CITY OF ROCKLIN

MEMORANDUM

RE: Granite Lakes Estates
Environmental Impact Report EIR-2000-01
General Development Plan PDG-2000-08
Tentative Subdivision Map SD-2000-02
Oak Tree Preservation Plan Permit TRE-2000-33
Development Agreement DA-2000-01
Design Guidelines for Grading DR-2002-02

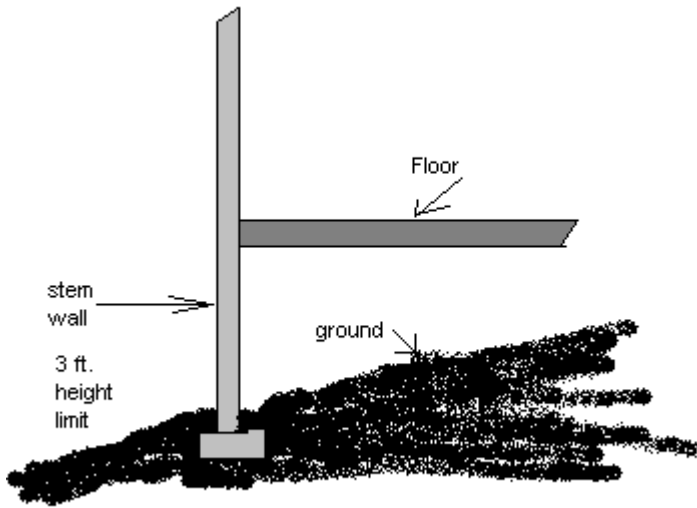
- a. Condition 13(b)(10) requiring regular monitoring of sediment depth within the detention facility (large quarry) and sediment removal (as determined necessary by the Director of Public Works) is recommended to apply to the existing pond as well.

Staff and the Commission also discussed the need to modify Condition 4(j) to clarify that oil and grit separator manholes or similar structures would be required at the last outfall before storm water is released to the creek consistent with typical City practices, as opposed to the original language which suggested that oil and grit separators would be installed in all drop inlets and the last outfall before storm water is released to the creek. However, formal modification of this condition was inadvertently omitted from the Commission's motion. It is staff's belief that the omission was an oversight and it has been included in the Council Resolution.

2) *Applicant Request for Reconsideration of Stem Wall Limitations*

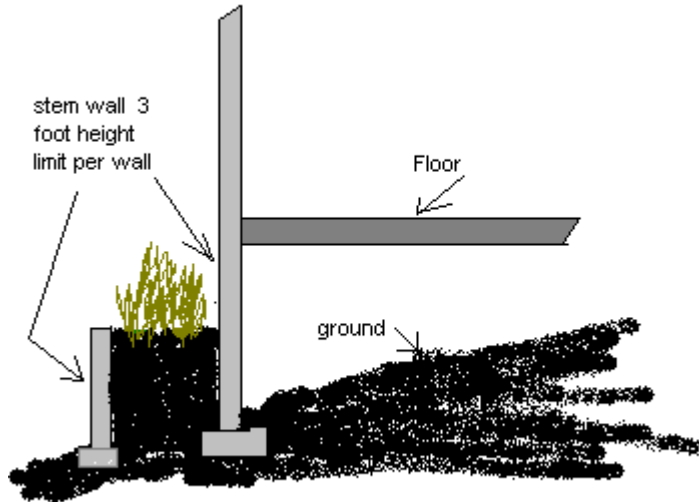
As noted in the Summary of Planning Commission Actions, the issue of limiting stem walls heights was raised. After some discussion, the Commission made the recommendation that the Grading Design Guidelines be modified to include a limitation prohibiting stem wall heights in excess of 3 feet in height.

Subsequent to the Planning Commission meeting, the applicant has expressed concern regarding how compliance with the proposed limitation would affect home construction on the limited graded and limited pad graded lots.

As noted in the April 25, 2002 memorandum from the firm of Terrance Lowell Associates (see Attachment 4), given the topography associated with these designated lots, the limitation on stem wall heights would either result in additional grading and tree removal and/or potentially preclude the ability to construct homes on such lots.

Although they understand the concern expressed by the Planning Commission (i.e., visual impacts to off-site existing residences and public views created by high stem walls in areas where homes constructed along ridge lines are well above existing homes and public rights-of-way); they note that the same types of physical conditions are not present within the Granite Lakes Estates site. The applicants suggest that most of the homes will not be visible to off-site residences, and that there are no conditions where existing homes sit well below those associated with the project. In light of those factors, they request that the Council eliminate the suggested stem wall restriction from the Grading Design Guidelines for the project.

In the past, the Planning Commission has expressed concern about the height and design of stemwall construction in other localized parts of the city (i.e. Rawhide Road, Whitney Oaks). Generally, the Planning Commission does not consider the issue of large stemwalls as solely a ridgeline issue. The internal views within the subdivision after construction of such a wall can also be impacted as well.

Staff recommends that a combination wall be constructed that would permit the use of stem walls over 3 feet in height, but would require the incorporation of a planter box or series of boxes so that the overall height of any one wall would not exceed 3 feet. In this way, no individual wall would exceed the 3-foot vertical distance recommended by the Planning Commission but some flexibility would be regained by the applicant to construct with greater stemwalls. The exhibit below depicts staff's recommendation.

If the City Council agrees with staff's recommendation, staff should be directed to incorporate the following language into the Grading Design Guidelines:

“In instances where structural stem walls over 3 feet in height are proposed, a planter box and/or series of planter boxes shall be incorporated adjacent to the stem wall so that the visible portion of the stem wall is no greater than 3 vertical feet. The planter boxes shall not be considered a part of the primary structure for purposes determining setbacks.”
